Docket No. 50-423
B11192

Millstone Nuclear Power Station, Unit 3
Transmittal of Response to Request for
Additional Information and Draft
SER Open Items
Structural and Geotechnical Engineering Branch (SGEB)

Question No. Q241.7 (Section 2.5.4.8.3 and SRP Section 2.5.4)

Dynamic Response Analysis of Beach Sand

FIGURE 2.5.4-75
SHOREFRONT PROFILE USED IN
LIQUEFACTION ANALYSES
MILLSTONE NUCLEAR POWER STATION
UNIT 3
FINAL SAFETY ANALYSIS REPORT

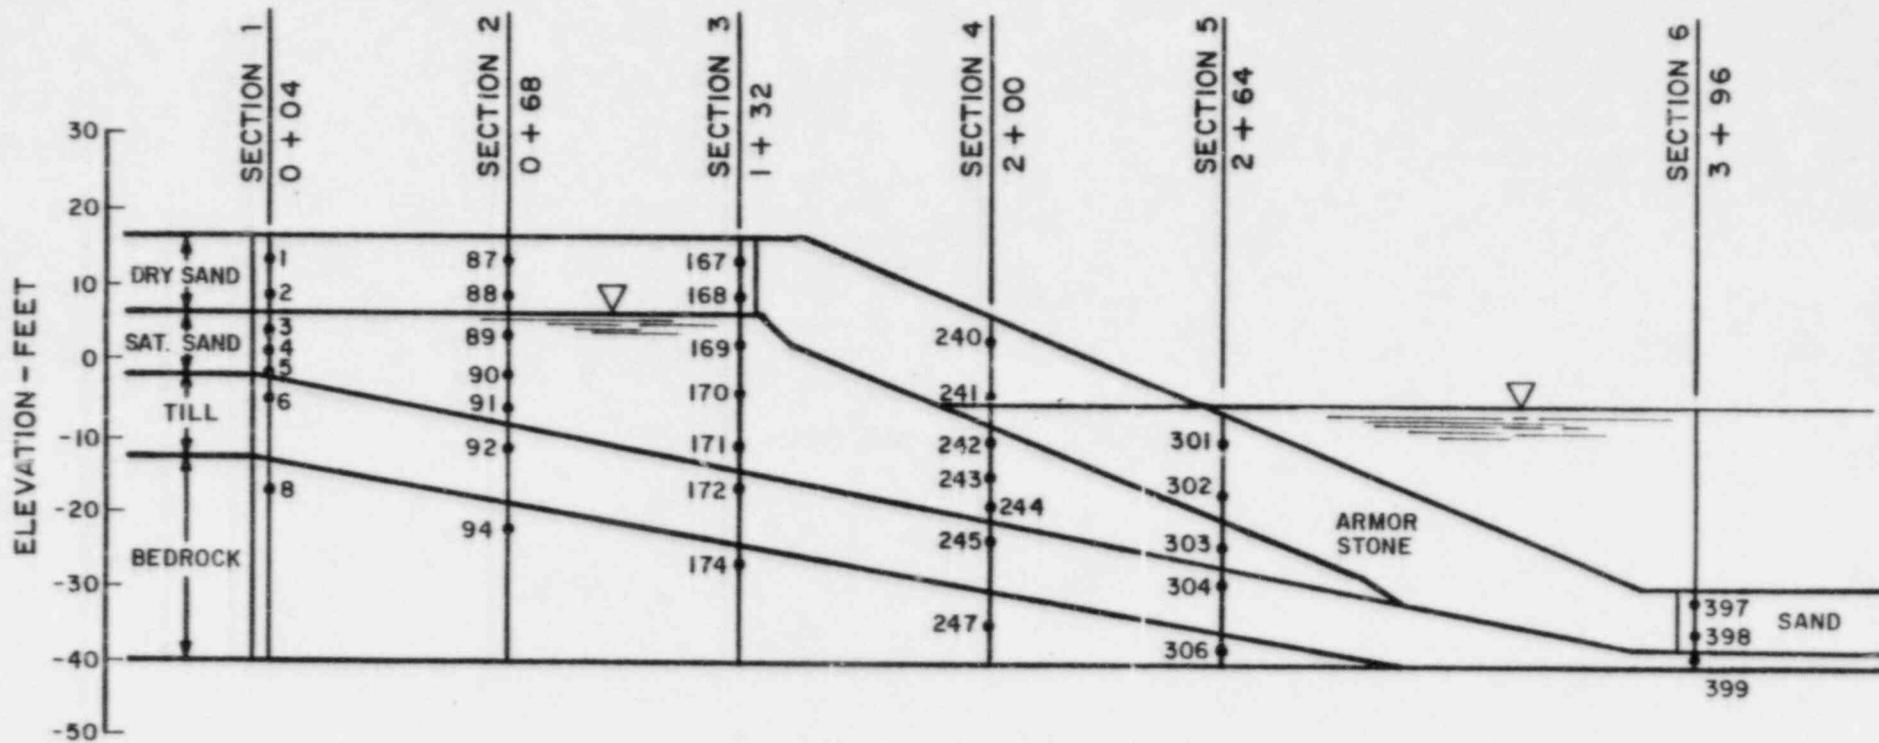
Section 2.5.4.4 of the Draft SER for Millstone Nuclear Power Station, Unit 3 (Reference 1) and Question 241.8 (Reference 2) request that a two-dimensional dynamic analysis be performed to confirm the stability of the beach sand deposits. The attached response (FSAR Section 2.5.4.8.3.3) provides a discussion of the results of this analysis and concludes that liquefaction of the shorefront slopes will not occur and that liquefaction of the intake channel bottom would not affect the integrity of the shorefront slopes adjacent to the circulating and service water pumphouse or result in a condition that would make the service water system inoperable.

Based on FSAR Figure 2.5.4-35, the thickness of beach sands varies from a few feet to about 50 feet and the thickness of basal till is also variable. In view of this variation of profile, justify that the one dimensional computer program SHAKE is suitable for analyzing the dynamic response of the shorefront sand deposits. Identify the location of the idealized profile used in the analyses. Substantiate the assumption that the groundwater is 10 feet below the ground surface using field monitoring results.

The profile used in the analysis is shown on Figure 2.5.4-75.

Liquefaction potential was calculated at each element for the 6 sections shown on this figure. The results of the PLAXLY analysis and the calculated values of Safety Factor against liquefaction are presented on Table 2.5.4-24.

The results of the analysis, presented on Table 2.5.4-24, indicate that the safety factor for elements 1 to 5 are all greater than 1.25. Low safety factors were determined for Section 6, mainly because of the low vertical effective stress near the surface of the intake channel at elevation -29 ft. The effective stress increases to the west of this profile location as the side-slopes of the intake channel rise to meet the natural ocean bottom, making these low safety factors a local phenomenon limited to the intake channel only. The post-earthquake slope stability analysis presented in Section 2.5.5.2.1 was reanalyzed to consider the effect of liquefaction of the sand in the intake channel (Soil 7 on Figure 2.5.5-4) on stability of the shorefront slopes. No change in the safety factor of the critical failure circle was calculated, indicating that the shorefront slopes would not fail in the event that the sand in the intake channel would liquefy.

It can be concluded from this analysis that liquefaction of the shorefront slopes will not occur and that liquefaction of the intake channel bottom would not effect the integrity of the shorefront slopes adjacent to the Circulating and Service Water Pumphouse. The soil underlying the service water pipe encasement adjacent to the pumphouse is not susceptible to liquefaction.
